Core Bus Corridor 16: Ringsend - Preliminary Submission

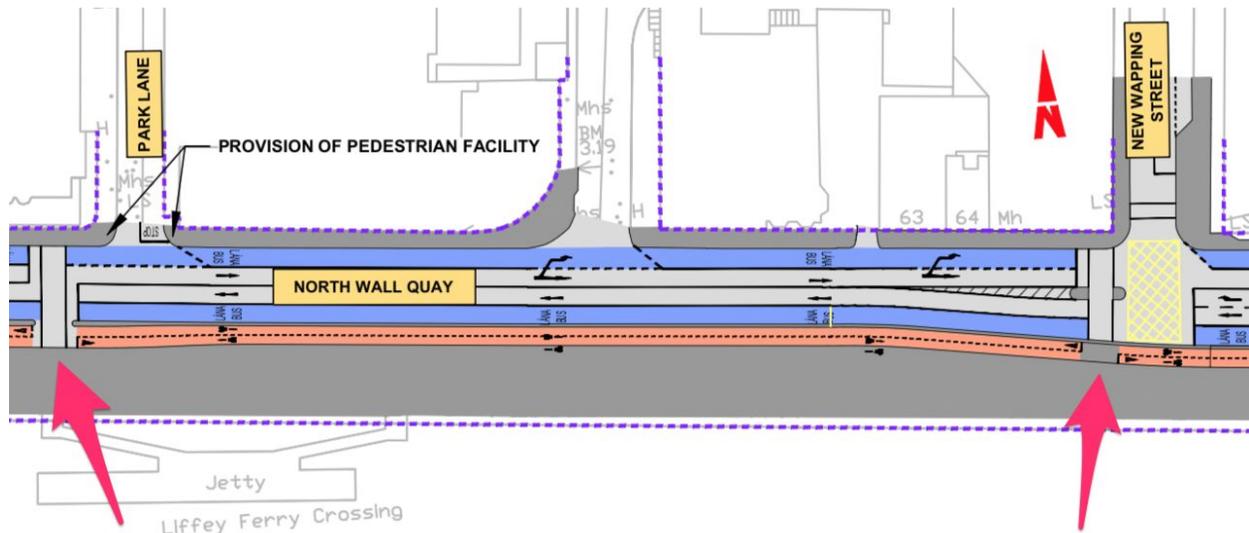
On the southbound side of Guild Street and Samuel Beckett Bridge (map 2) the cycle track is currently two-way. This is a key link between the Royal and Grand Canal Cycleways. These cycleways are part of National Route 10 and Primary Route NO1 of the GDA Cycle Network Plan. We hope that this is a mapping error, as page 11 of the public consultation document says that the "*cycle facilities on Samuel Beckett Bridge will be maintained*".

Extract of the GDA Cycle Network Plan for the Ringsend area

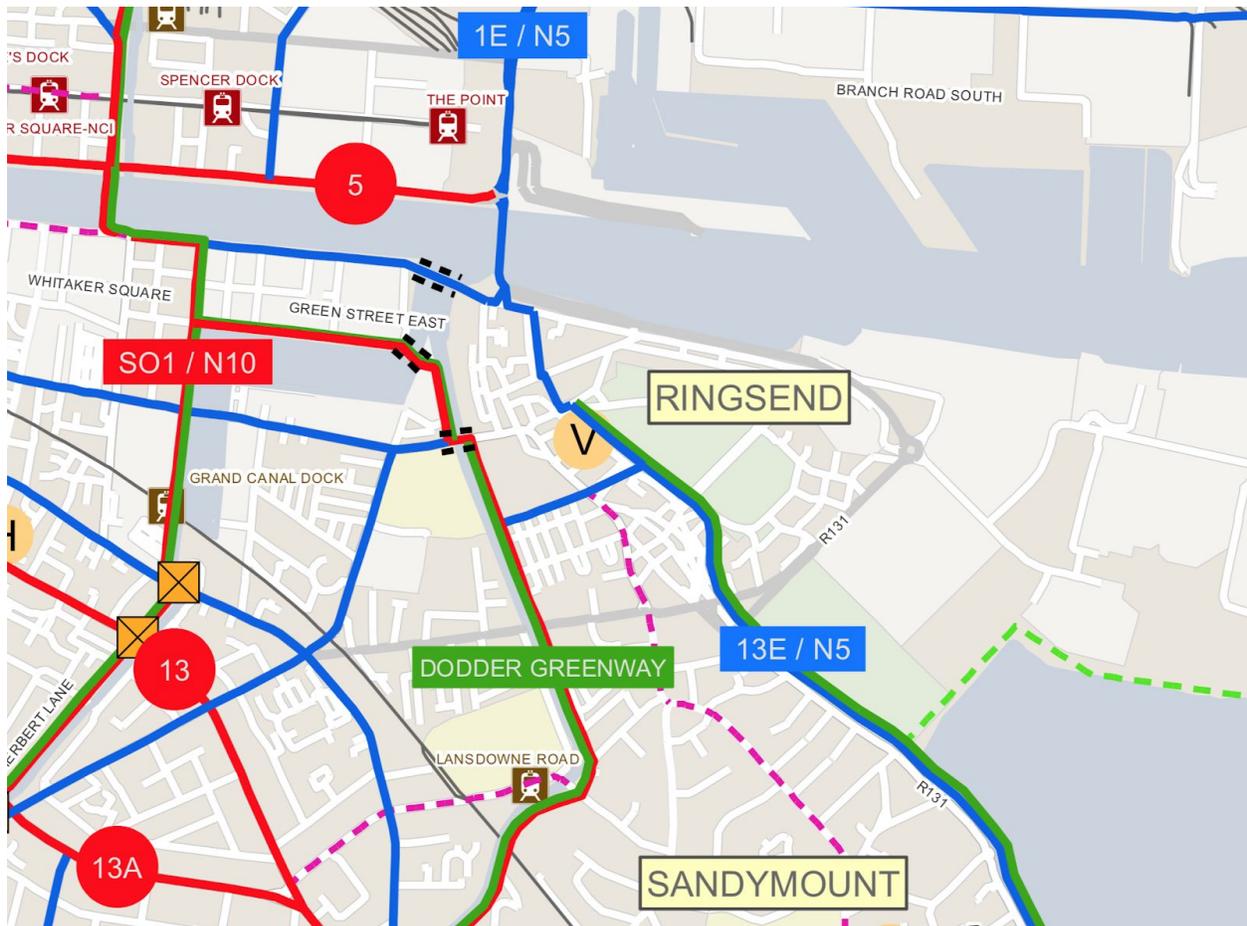
Map 6-10 shows the proposed East Coast Trail. We question why the East Coast Trail is continuing along York Road and runs parallel to Sean Moore Road through Ringsend Park. The proposed route is 1.45km long. The indicative route in the GDA Cycle Network Plan is a more direct through Pembroke Cottages the southern edge of

Ringsend Park to Sean Moore Road is 950m long (50% shorter than the proposed route). We understand the the emerging preferred route in the options report included bus and cycle lanes all to Sean Moore Road and this may have influenced cycle route choice.

The indicative route in the GDA Cycle Network Plan uses Pembroke Cottages. Since the emerging preferred route of the Dodder Greenway will use Thorncastle street it be easier to continue the route along the wide Cambridge street to the dedicated cycle facilities planned for Thorncastle Street as part of the Dodder Greenway.
